## ADDENDUM NO. 5

**Date:** October 11, 2016

**Project:** SMCC Culinary Arts Building Renovation  
South Portland, Maine

**3 GAS PIPING EXTERIOR ELEVATION 2**  
 MP101 NOT TO SCALE

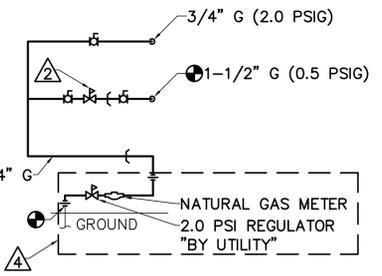
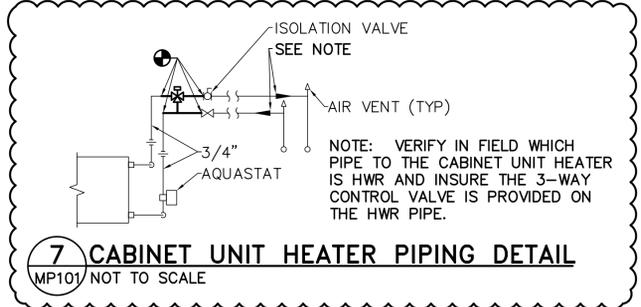
Question: *On drawing MP101, details 3 and 5 have keynote 2 which requires a contractor provided gas pressure regulator. I will need to know the connected load to price the regulators. These two regulators serve existing gas lines and equipment.*

Response: *Refer to addendum item for drawing MP101.*

- △ PROVIDE NATURAL GAS PRESSURE REGULATOR TO REDUCE BUILDING GAS PRESSURE FROM 2.0 PSI TO 0.5 PSI. THE REGULATOR NATURAL GAS ENERGY SUPPLY CAPACITY SHALL BE NOT LESS THAN 800,000 BTU/HOUR.
